**Minutes of the Meeting
January 15th, 1998**

Projects Reviewed

705 Charles Street
Nordstrom Office Building (7th and Olive)
Denny Way/Lake Union CSO Control Project
Weller Street Bridge
Bell Town P-Patch
Seaboard Lumber
North Service Center

011598.4 Project: **Denny Way/Lake Union CSO Control Project**
 Phase: Briefing
 Presenters: Kate Boris-Brown, Norton, Arnold & Janeway
 Judy Cochran, King County Wastewater Division
 Laura Haddad, Artist
 Greg Hill, Streeter & Associates
 Carol Valenta, King County Public Art
 Time: .75 hr. (N/C)

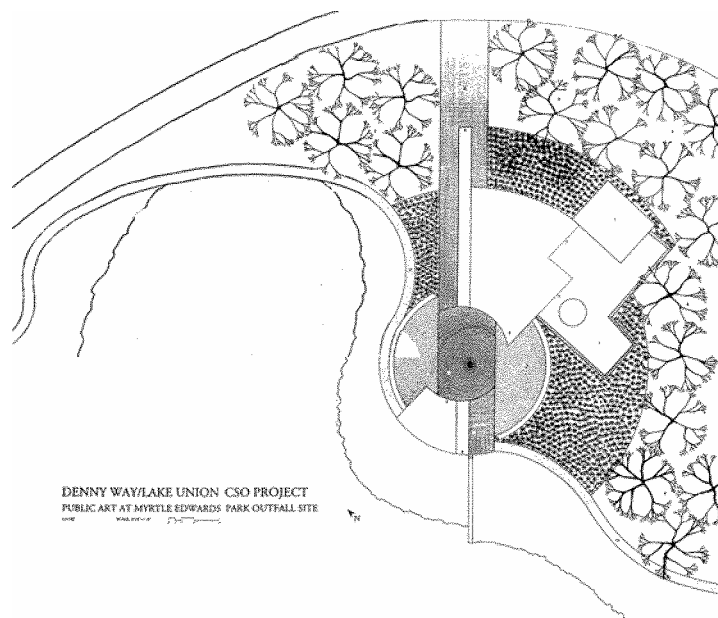
- Swift:** This is definitely a hostile pedestrian site. Its urban context is dominated by the Queen Anne hillside, the simple horizontal plane of Elliott Bay, and the filled edge of the shore. This project is going into a historically industrial context, meaning the forms were simple. I have a personal attitude about the decoration of modernist forms of architecture and am concerned about the project moving quickly from a massing model to the development of facade patterns. The missing step seems to be consideration of skin depth and using fenestration to develop more detail and shadow rather than visually flat brick patterns. Windows seem to be a good place to develop depth in the facade. I urge you to look at the transition between massing and surface treatment.

- Dubrow:** I agree. I wonder if the street will have more pedestrian use in the future. I wonder if the orientation of the building could be more successful with the long side along the street.

- Dubrow:** The transition of the building forms down toward the water might also be reinforced if the design was rotated.
- Hill:** Functional issues pushed the building up against the street. We tried to switch the building, but piping complications made it impossible. The actual facade length is similar on either side. We are also trying to create an edge for the street.

- Layzer:** Does the form have to follow the function? Perhaps reflecting the context not the function would be better?
- Hill:** Rotating the building 90 degrees creates many engineering problems. We are trying to work with the engineering functions of the project and articulate that through the architecture. We haven't been able to justify form changes to engineering.

- Cochran:** The function of the building has to come first. The building orientation is determined mainly by the tunnel under Elliot Avenue and how the pipes need to access the site. There is also an unvacated portion of Mercer Street on the site. We are trying to keep all above ground facilities off of that area.

C. QUEEN ANNE STANDPIPE AND PUMP STATION: The Commission had the following discussion with Eugene Manchev, an engineer on the project. A subcommittee consisting of Commissioners Batra, Dubrow, and Sundberg was appointed

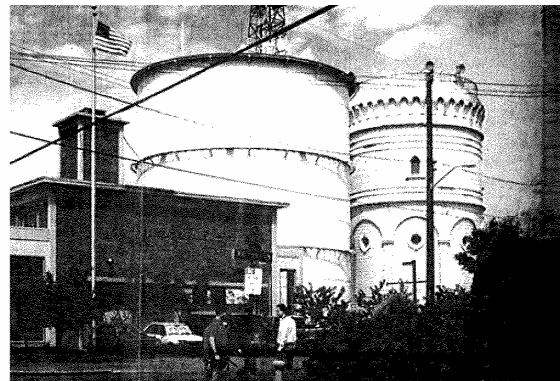
- Manchev:** The size and capacity has not been changed. We identified a need of three million gallons, but realized that we couldn't do that with the two tennis courts in the way.

- Wagoner:** The Commission does build on past actions, and should probably not redirect the project in regards to two tanks.
- Sundberg:** The major issue is the detail and scale of the new tank. The smooth sides with graphic applications does not address either of these issues. I value the historic structures.

doesn't reflect the issues of scaling and detail. The scaling is more than surface treatment, it includes urban fit, and massing. Look for ways to provide scale on the exterior of the structure, to breakdown the size of it.

Swift: Are there internal ribs or framing that could be pulled to the outside? Perhaps the steel panels could be connected in a way that reflects this connection and creates scaling elements. If this structure was placed at Boeing Field, it would be compatible. But you are putting this into a residential neighborhood.

Dubrow: The increased capacity is a difficult issue. Could the tank be set underground part way?

Dubrow: Perhaps you should get another consultant. I don't want to pick between the functional advantages of a larger tank and the scale issues. I think we can have both with the right design. It is difficult to make a decision without a presentation of engineering issues.

Manchev: We ran that idea by a structural designer who said that it wasn't feasible. The tank needs a base underneath it to handle seismic loads.

Manchev: Our structural consultant said it was nearly impossible without enormous costs.

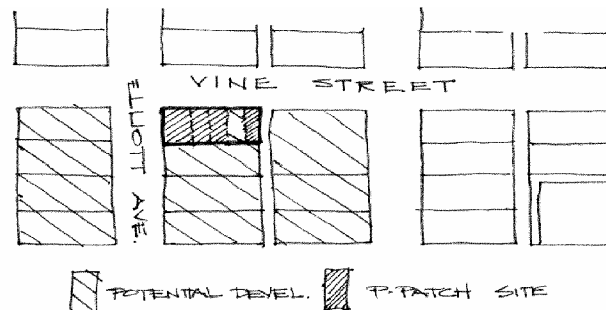
- Posthuma:** No.
- Hansmire:** The landing looks more architectural than bridge-like. Perhaps separating the cover over the bridge from the massive, monumental west end would lighten the bridge and reinforce it springing over the tracks.

- Dubrow:** That kind of separation would also enhance the gates at each end, giving the artist room to develop the bridge as a single unit.
- Posthuma:** There will also be a City Light feeder installed underneath the bridge, so it does serve a dual function.

- explore the connection of the bridge with the elevator core, possibly varying the roof forms;
- explore a more symmetrical approach to the stairs and elevator core.
